**MINUTES (Part 1) OF THE 14th MEETING OF STATE LEVEL EXPERT APPRAISAL COMMITTEE (SEAC), JHARKHAND HELD ON 18<sup>th</sup>, 20<sup>th</sup> to 22<sup>nd</sup> February 2014.**

**Hazardous Waste Management Facility of M/s Adityapur Auto Cluster at Village Dugni, Tehsil Saraikella District Saraikela Kharsawan, Jharkhand.**

**Site Visit report of Hazardous Waste Disposal Facility at Village Dungi, District Saraikela Kharaswan .**

Proposed Layout Plan of  
HWMF at Dugni, Distt.  
Sataikella Kharsawan  
(Alternative B)

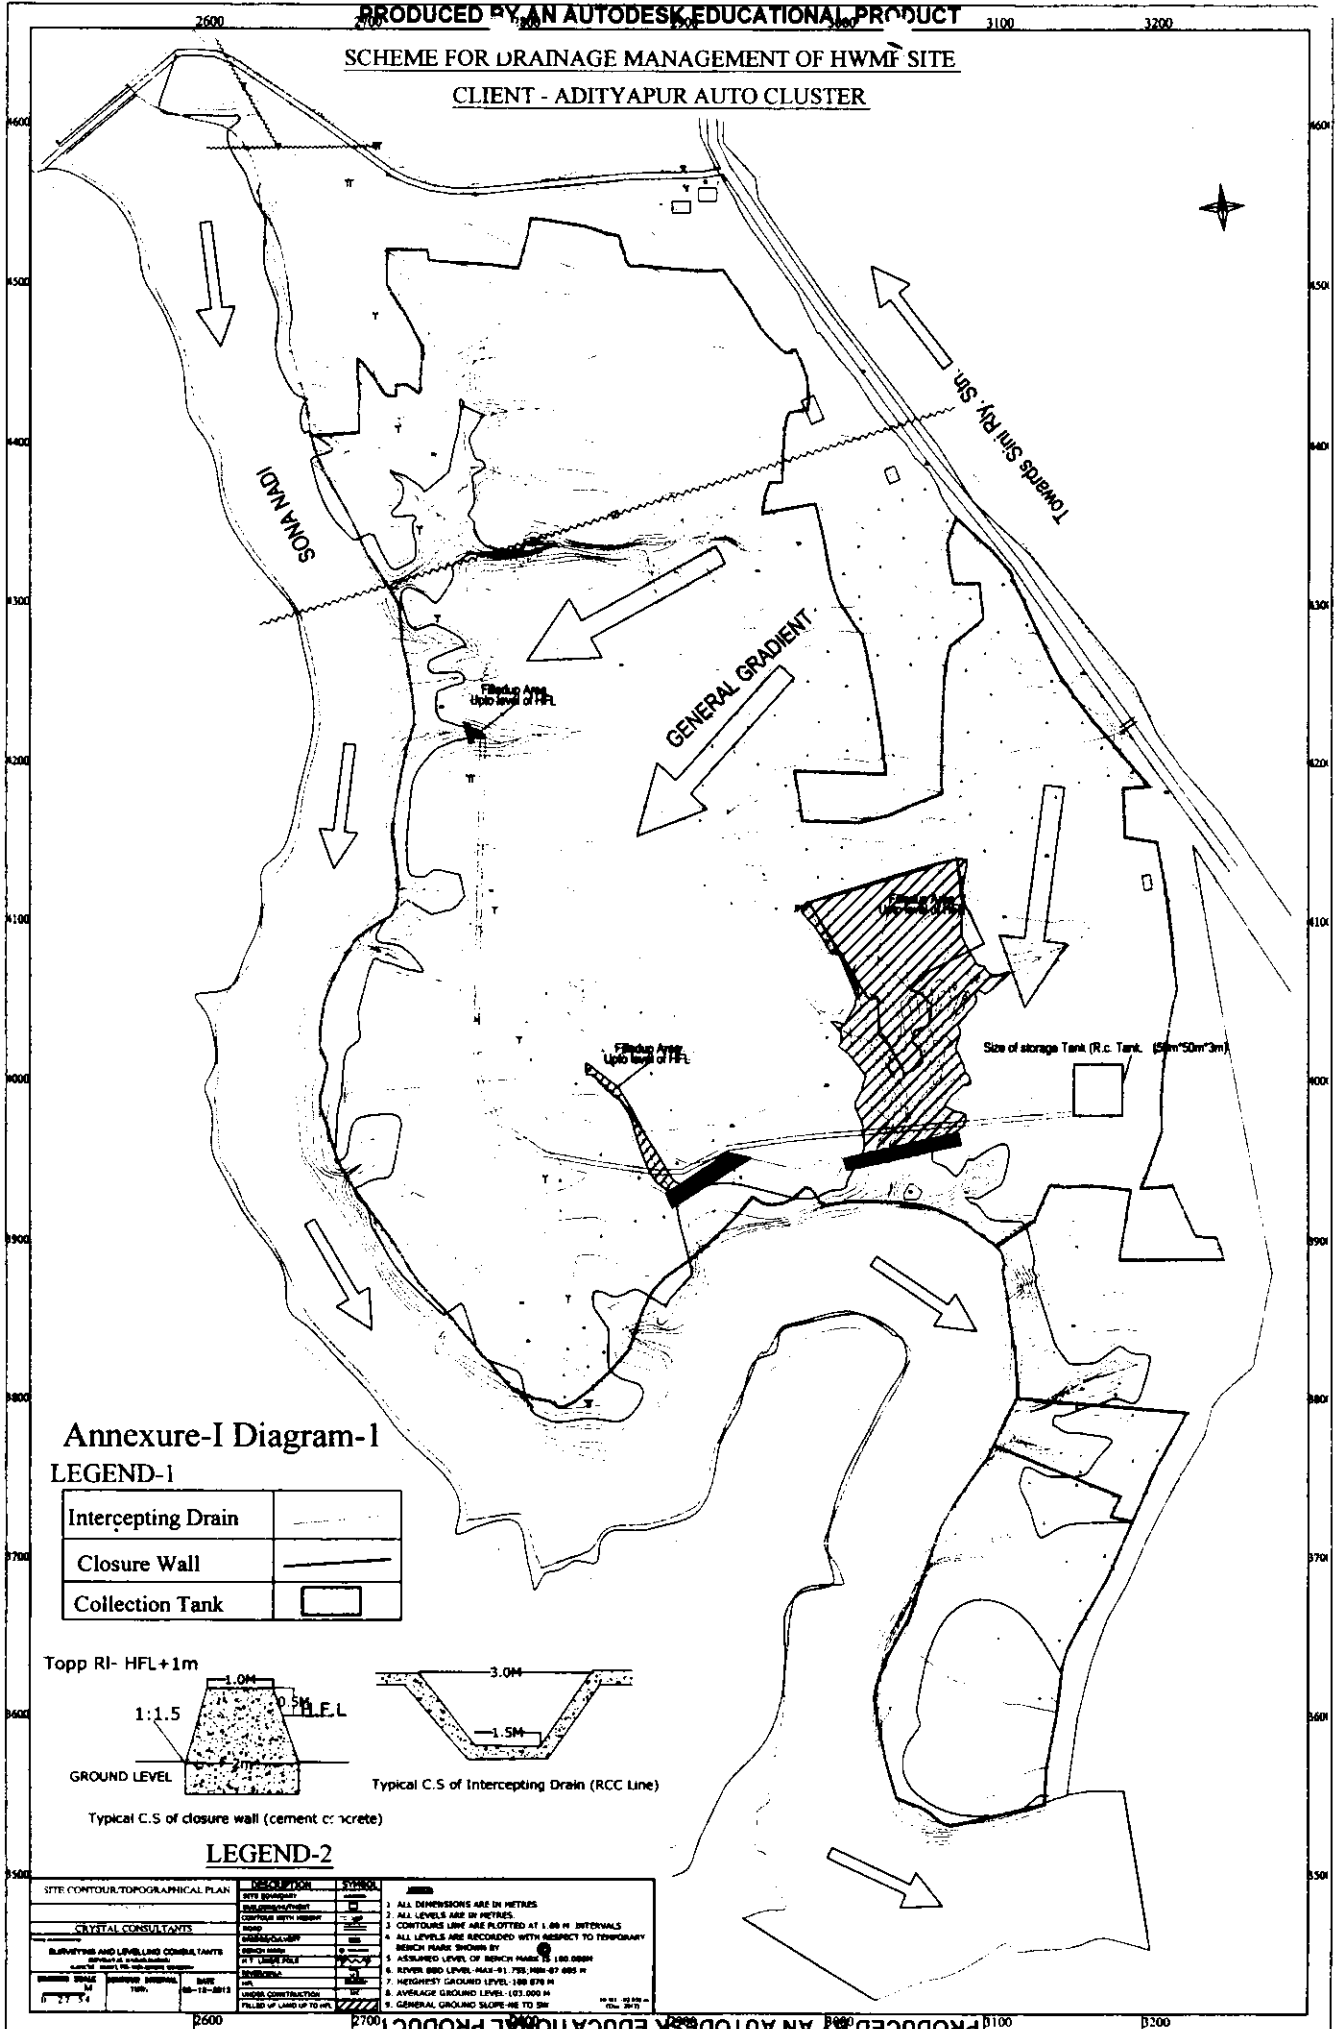
- viii. Distance of lake or pond in the radius of 200M from the landfill site. In this connection a certificate from local body is required by PP.
5. PP was asked to submit – contour map of the site with drainage map and details of landfill locations with distance of same w.r.t. Sona Nadi.

Looking to above facts - the matter may be discussed in detail in the next SEAC meeting and technical appraisal report based on inspection report and facts available in EIA report must be conveyed to SEIAA for further needful action at their level. The map of proposed landfill site is enclosed for further needful action.
